Proposed 3 Unit Small Lot Subdivision: 4044 Madison Ave. Culver City, CA 90232 - 3220

# Preliminary Project Review (PPR) Comments –February 28, 2019, PRC Meeting 4044 Madison – New 3-Unit Townhome Subdivision Brief description: PPR request for Tentative Parcel Map and Administrative Site Plan Review for three unit townhome subdivision on a 6.750 square foot site. An existing single family home and accessory rear structures on the site will be demolished. Planning Division - William Kavadas (310) 253-5706 Preliminary Project Requirements A. The project is subject to Title 17 (Zoning Code) and Title 15 (Land Usage) of the Culver City Municipal Code (CCMC). Specific sections that apply are listed below. Other sections of the Zoning Code may still apply. Title 17 Chapters: Chanter 17 210 - Residential Zoning Districts

PPR RESPONSES - 10/29/20

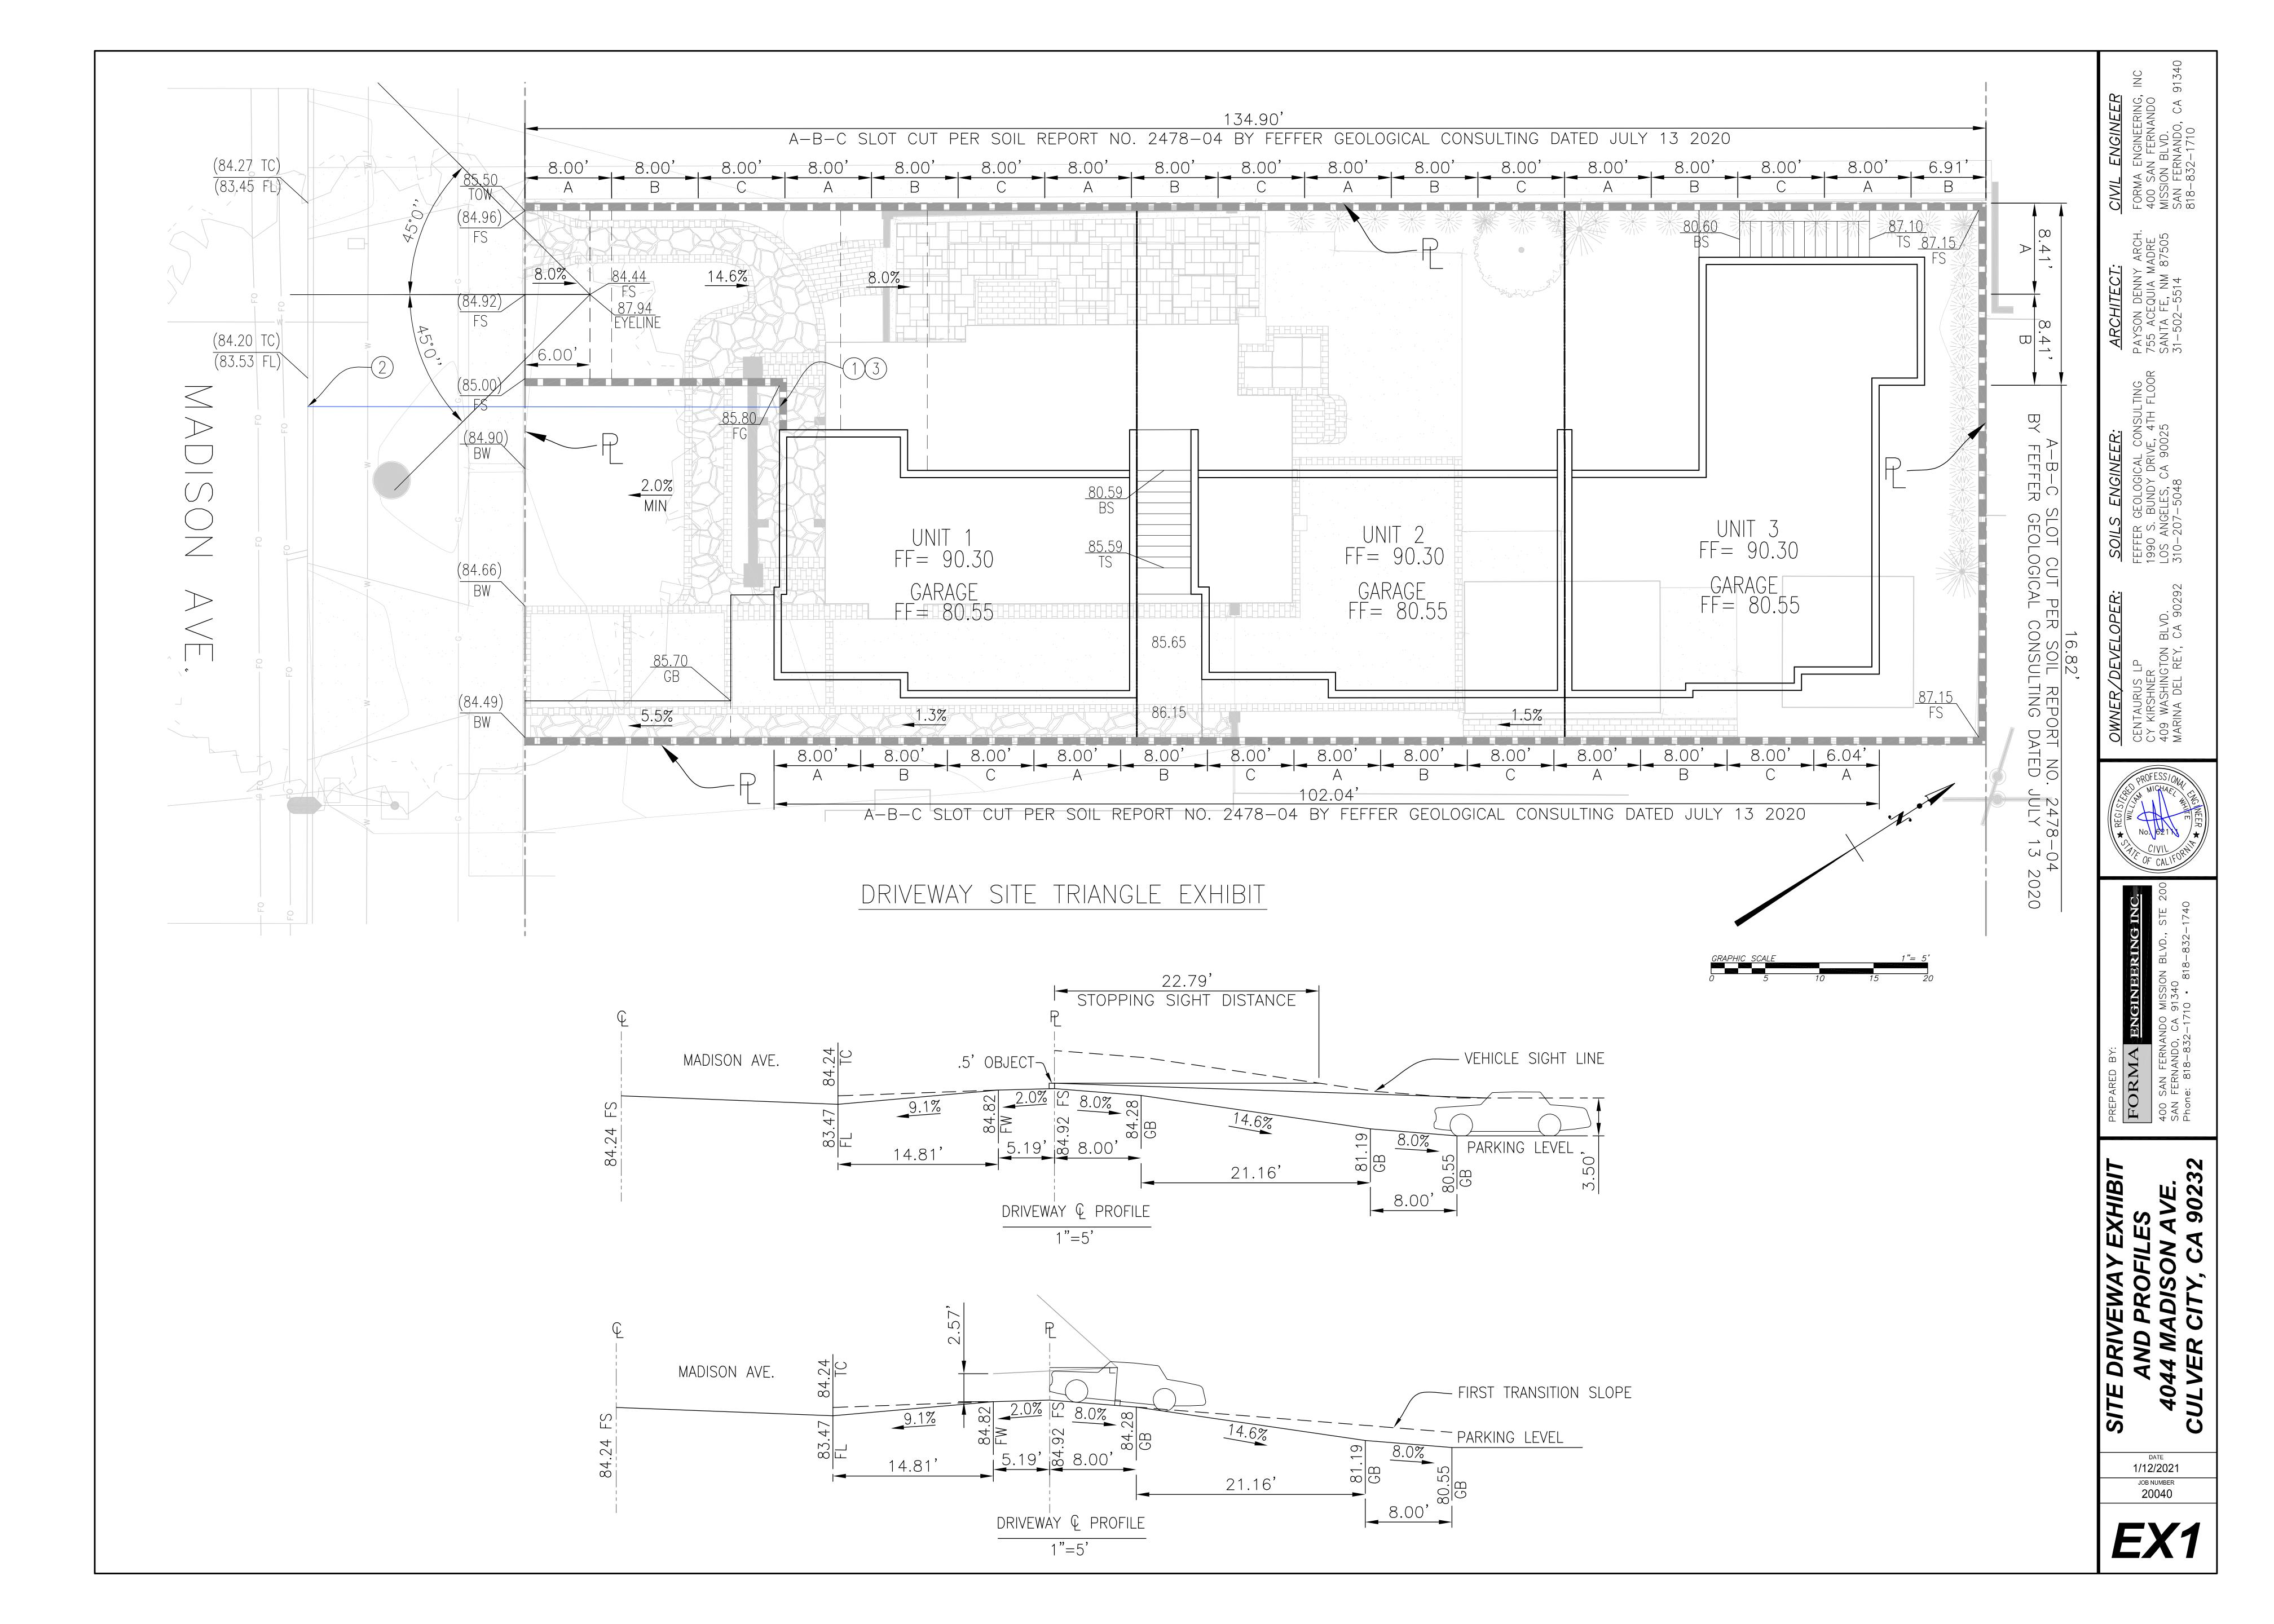
The proposed multi-story layout of the project does not comply with Municipal Code Standard. While subterranean garage parking stalls are permitted, the addition of a habitable space on the subterranean level creates a story which exceeds the story and height limit of the proposed project. Only a fully subterranean story will be considered a basement. Please revise plans accordingly.

- 1. VI.A.1.a Establish setbacks that are consistent with the prevailing setbacks along the block where the project is located
  - The project currently meets a 21 setback. The average setback in Block C is 23 feet and the prevailing is 25 feet. Staff will be looking for setbacks within this range that are consistent with the existing neighborhood character.

- 20. Per the definition of a bedroom by the Municipal Code, the proposed middle unit has four "bedrooms". Per Municipal Code parking standard, the proposed middle unit needs three parking spaces. Please reduce the number of bedrooms or increase the number of parking spaces as appropriate.

- 21. The garage carport is too small. Minimum interior dimensions for carports is 10 feet 6 inches by 18 feet wide. In addition the carport turning radius does not work, as it backs into the other parking space. Please revise parking so that the garage carport space has an unencumbered entrance/exit from its parking space.

- 3 VI.A.1.d Reduce massing along south side property line. Added step backs and replaced taller flat roof elements with lower sloped roof masses.
- 4 VI.A.1.e Reduce lot coverage to below 40%. Lot coverage is now 39%.

- 5 VI.A.1.f Add more to 5'-0" side yard setback and revise massing to allow for more light in south side yard. Majority of 1<sup>st</sup> floor is now 6'-0" or greater set back. Masses facing South side yard reduced by roofs sloping down towards the side yard.

- 20 **Plan contains 4 bedrooms.** Plans have been redesigned to eliminate the 4th bedroom.
- 21 Carport is too small. Garage level has been redesigned. All parking meets code requirements.
